1.) I believe that I am one of the original and first inventors of the subject matter which is claimed and for which a patent is sought on the invention entitled: "A Multiple and Parallel Access Network Tap for Gigabit Internet LANS", the specification of which was filed on Sept. 19, 2003, as the United States Application Number 10/667,107, and as amended with the papers submitted along with this declaration and petition.

Also submitted, in anticipation of the approval of these changes as those requested by the Office, is a set of Replacement Drawings 1-7, all with the descriptive text labels included and, as directed in the Office Action, each properly labeled as a ‘Replacement Sheet’ in each top margin.

FIG. 4 Interior top view

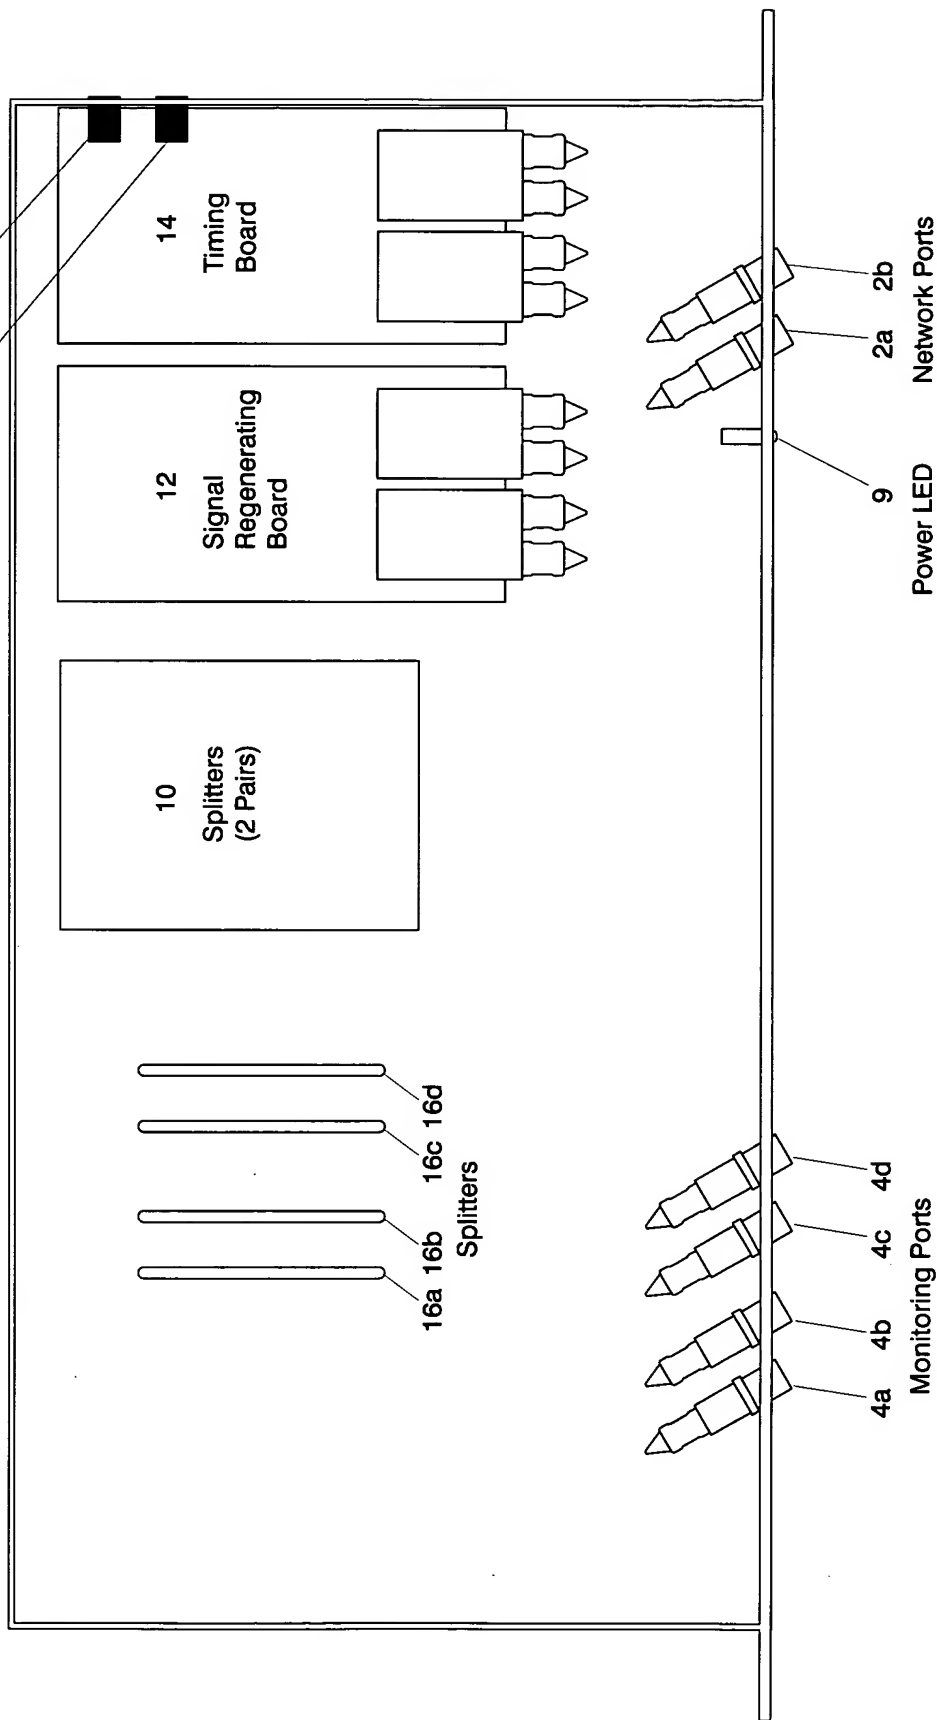
“Timing Board”, and [18, 17] labeled “Power Supply Connections”. It is labeled “Interior top view”.

FIG. 5 Interior top view with logical cabling paths and port offsets for clarity

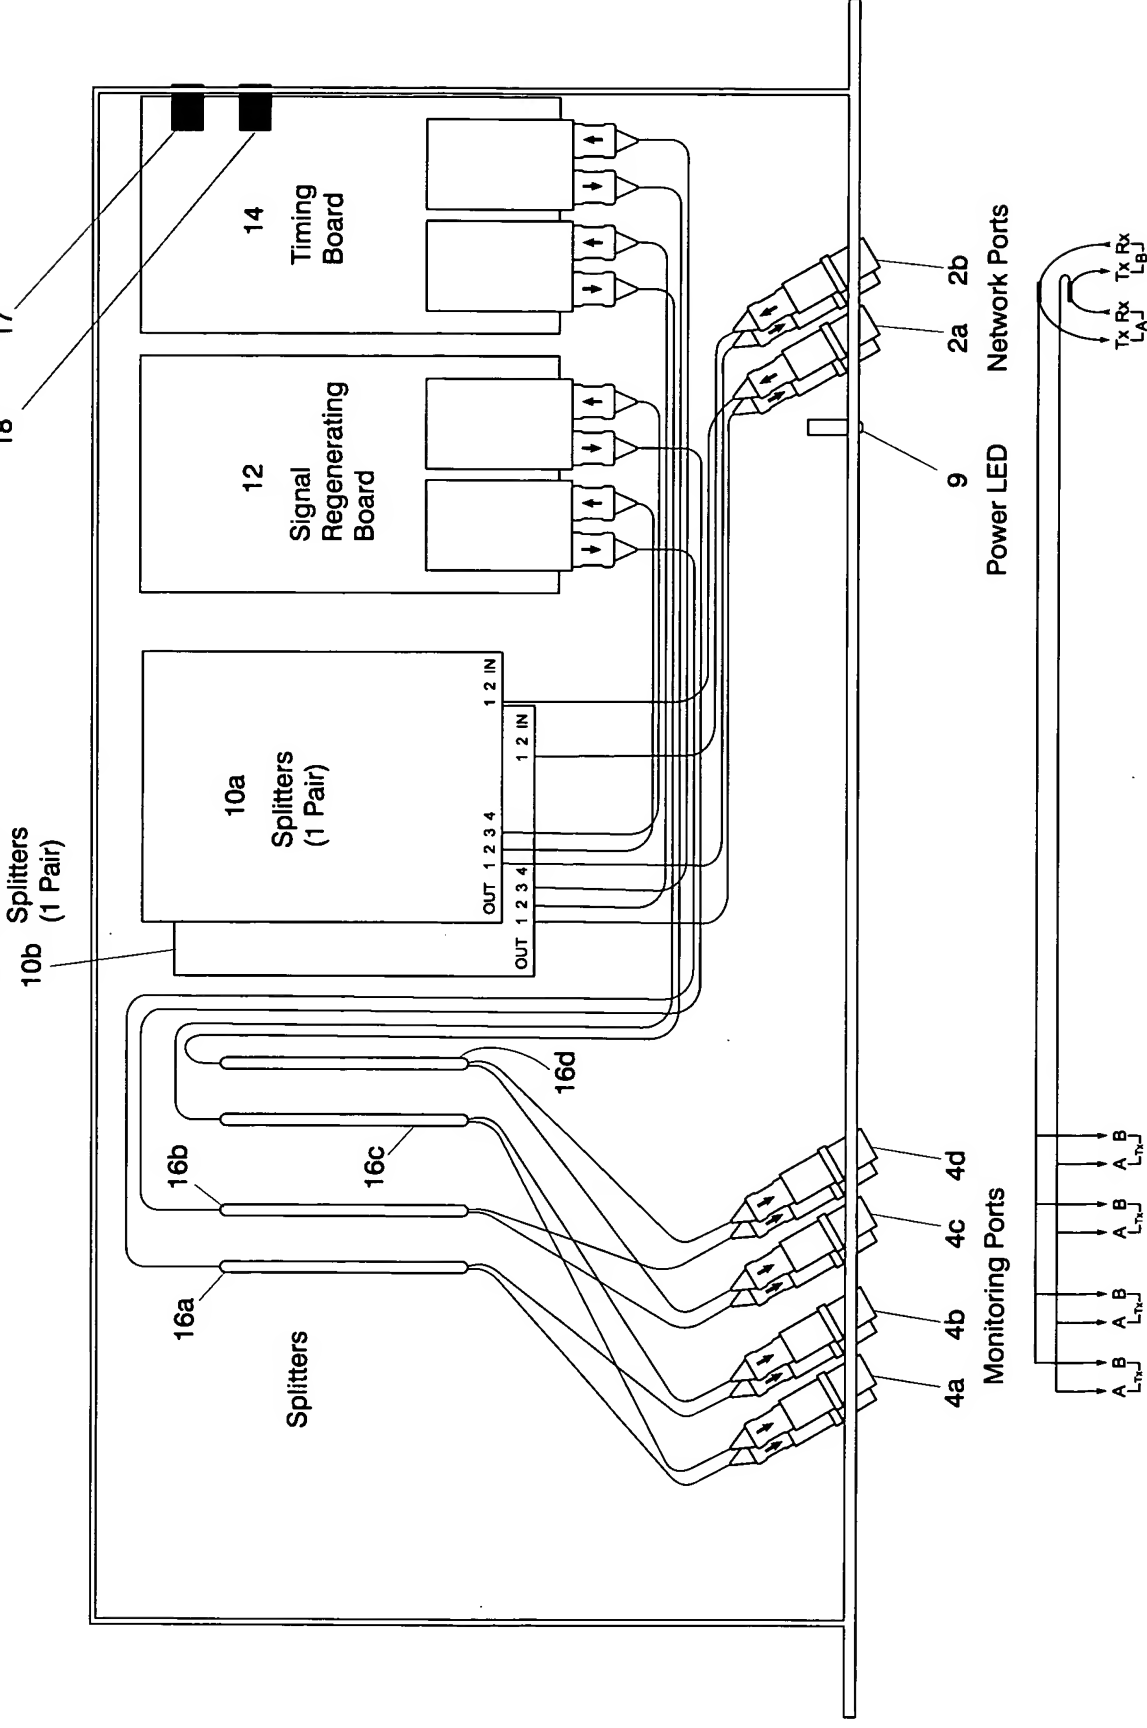
Figure 5, read left-to-right, has had [4a-4d] labeled “Monitoring Ports”, [16a-16d] labeled “Splitters”, [10b] labeled “Splitters (1 Pair)”, [10a] labeled “Splitters (1 Pair)”, [9] labeled “Power LED”, [12] labeled “Signal Regenerating Board”, [2a-2b] labeled “Network Ports”, [14] labeled “Timing Board”, and [18, 17] labeled “Power Supply Connections”. It is labeled “Interior Top View with logical cabling pathes and port offsets for clarity”.

FIG. 6 Interior top view with logical front view

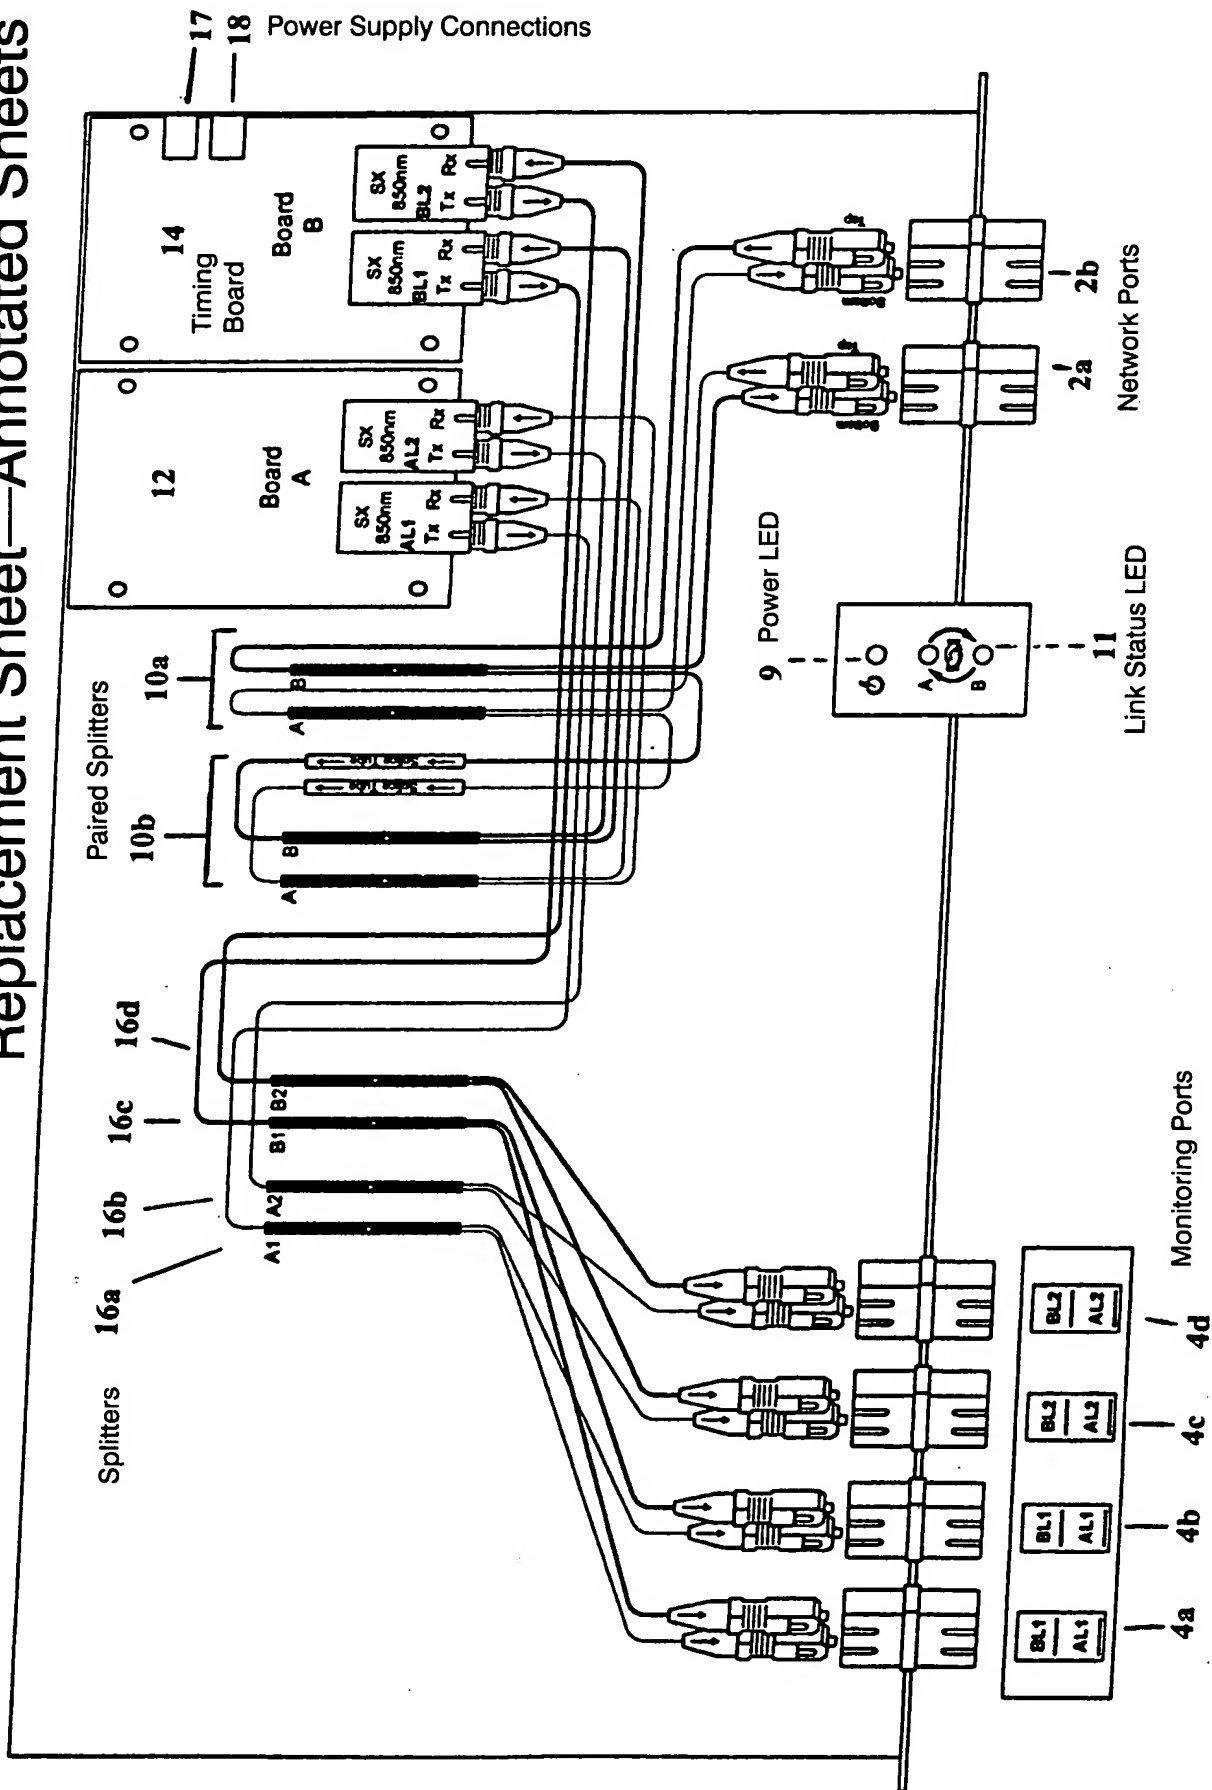
Figure 6, read left-to-right, has had [4a-4d] labeled “Monitoring Ports”, [16a-16d] labeled “Splitters”, [10b, 10a] labeled “Paired Splitters”, [9] labeled “Power LED”, [11] labeled “Link Status LED”, [12] labeled “Board A”, [2a-2b] labeled “Network Ports”, [14] labeled “Timing Board Board B”, and [17, 18] labeled “Power Supply Connections”. It is labeled “Interior top view with logical front view”.

FIG. 7 Interior top view with logical front view modified for monitoring input

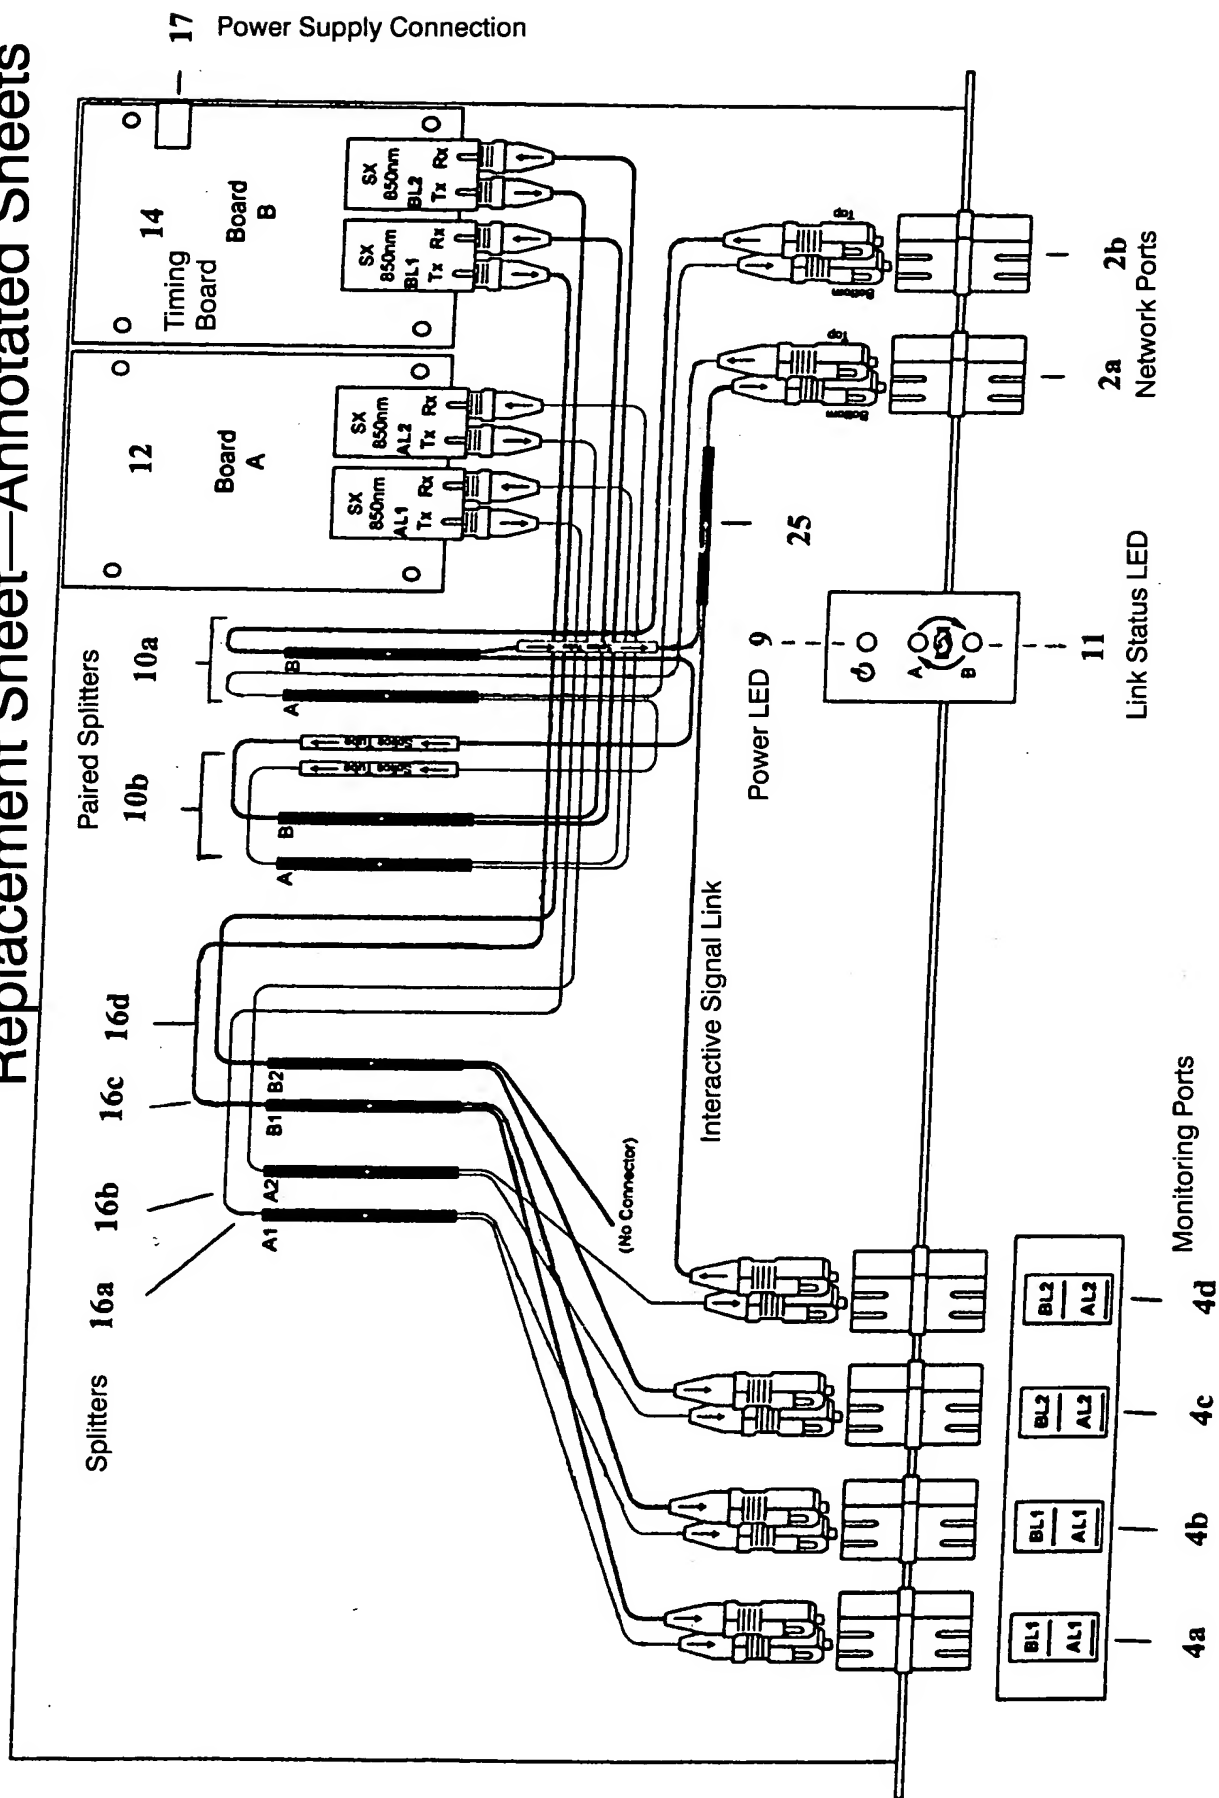
Figure 7, read left-to-right, has had [4a-4d] labeled “Monitoring Ports”, [16a-16d] labeled “Splitters”, [10b, 10a] labeled “Paired Splitters”, [9] labeled “Power LED”, [11] labeled “Link Status LED”, [12] labeled “Board A”, [2a-2b] labeled “Network Ports”, [14] labeled “Timing Board Board B”, and [17] labeled “Power Supply Connection”. It is labeled “Interior top view with logical front view modified for monitoring input”.
